DraftPreliminaryHRSC_CSM_FID_082416_TowerStandard.4dm - 4DIM Player
Author: Jason C. Ruf
Organization: S2C2 Inc.
Description: Draft CSM for High Resoluti...
Tower Standard Site
Lac du Flambeau, Wisconsin
Data Analysis and Data Visualization Report
August 2016
Vertical Exaggeration is 2.5x
MIP-FID above 50,000 uV
MIP-FID
10,000,000 uV
3,000,000 uV
1,000,000 uV
300,000 uV
100,000 uV
30,000 uV
10,000 uV
Total VOCs
1,000,000 ug/kg
300,000 ug/kg
100,000 ug/kg
30,000 ug/kg
10,000 ug/kg
3,000 ug/kg
1,000 ug/kg
300 ug/kg
100 ug/kg
30 ug/kg
10 ug/kg
3 ug/kg
1 ug/kg
2D Maximum Plume
1,990,400
1,990,500
1,990,600
1,990,700
Easting
NOTES:
See Data Analysis and Data Visualization Report for data visualization details.
S2 C2 inc.
Inbox - Mailbox - Kady, Tom - Outlook
RE: Recommendations for additional well locations at the Tower Standard site
Hi Bob – I've included below in red some of the logic and additional details from our discussion on the proposed monitoring well locations. I believe this information will help to provide some boundary conditions to improve the accuracy of the 3D data visualization and to help provide a reliable basis to quantify the mass distribution of contaminants across

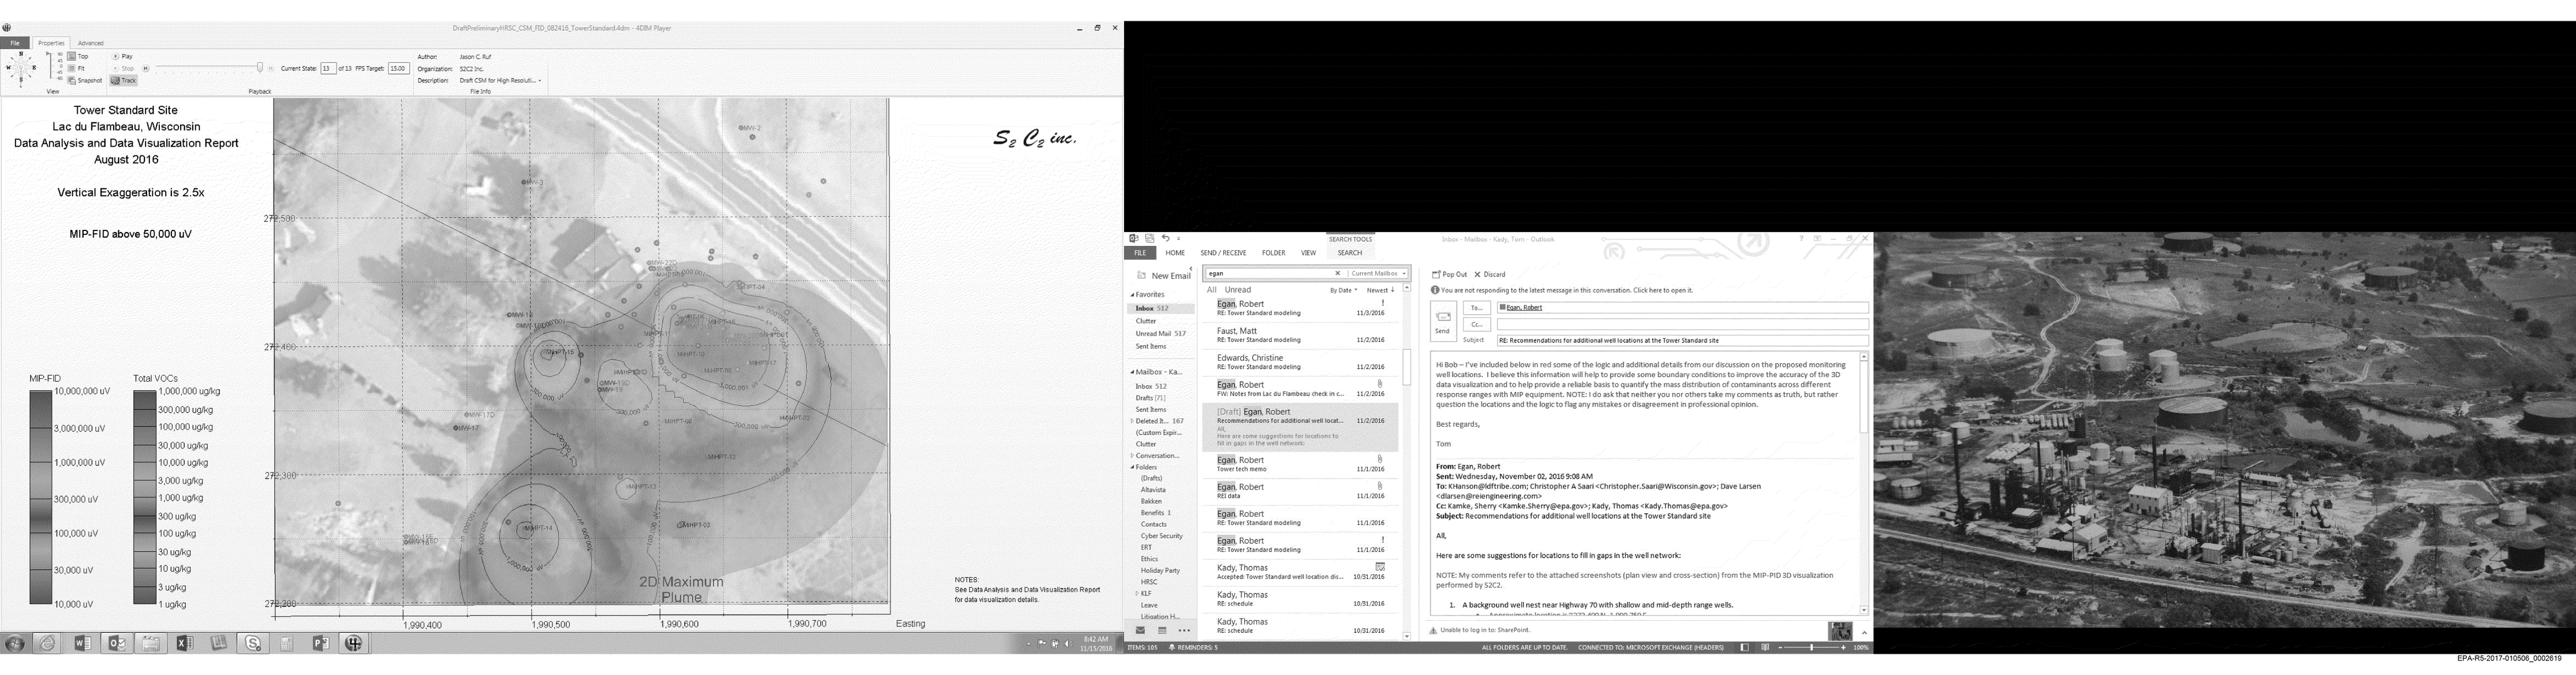
1. A background well nest near Highway 70 with shallow and mid-depth range wells.
8:42 AM
11/15/2016
